TOWN OF CARMEL
ENVIRONMENTAL CONSERVATION BOARD

ENVIRONMENTAL CONSERVATION BOARD AGENDA
JUNE 16, 2016 – 7:30 P.M.

**Re: 390 East Lake Boulevard
Application for Wetlands Permit**

SW-1

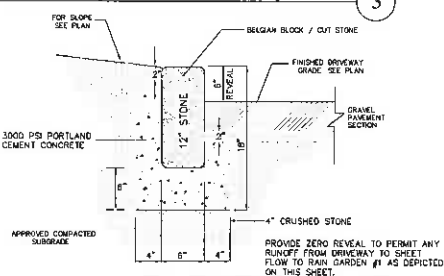
2. *Provide a "spill kit" for the machine to do the work in the wetland.*

3. *Provide a fueling plan – provide a location where refueling will be performed. Indicate what protection will be done to avoid impacts to the buffer.*

7. *Show the electric line to be installed from the house to the well.*

8. *Indicate that the former well will be abandoned in accordance with NYSDEC protocols. The abandonment is to be done by a licensed well driller.*

9. *Include silt fence around the perimeter of the disturbance from the trenching.*

11. *Shorten the length of the perforated storm pipe to the length of the wetland "finger". Eliminate the pipe where the wetland broadens out.*

The contractor will be required to have a spill kit present on the property in the event there is a spill of fuel or products that would be detrimental to the wetland or buffer. A note to this effect is provided on the plan (see drawing SW-1 and EC-1).

Refueling is to be done on the east (right) side of the house over the future driveway footprint. The proposed location is outside of the wetland boundary, though within the buffer. A fuel containment berm which can temporarily hold spilled fuel will be installed in the fueling location during construction.

The location of the electric line to be installed from the house to the well is depicted on drawing SW-1. The electric line will be installed in accordance with the National Electrical Code and New York State Building Code for direct buried cable or conduit. Underground warning tape shall be installed above the cable as per regulations.

Note 5 on drawing SW-1 has been added to the plans: "The former well on the property shall be abandoned in accordance with New York State Department of Health and Department of Environmental Conservation protocols, as well as in accordance with the Putnam County Health Department rules and regulations. Former well shall be abandoned by a licensed well driller licensed in the State of New York." In addition, the former well is flagged on drawing SW-1 to be abandoned and reference to note 5 of the notes on drawing SW-1 has also been added to the plan.

Silt fence, as requested, has been added around the perimeter of the disturbance from the trenching to install the electric line from the house to the well and the water service line from the well to the house.

As requested, the proposed perforated pipe has been removed from upper portion of the wetland; the perforated pipe is now only to be installed in the wetland "finger" between the house and Wixson Pond Road.
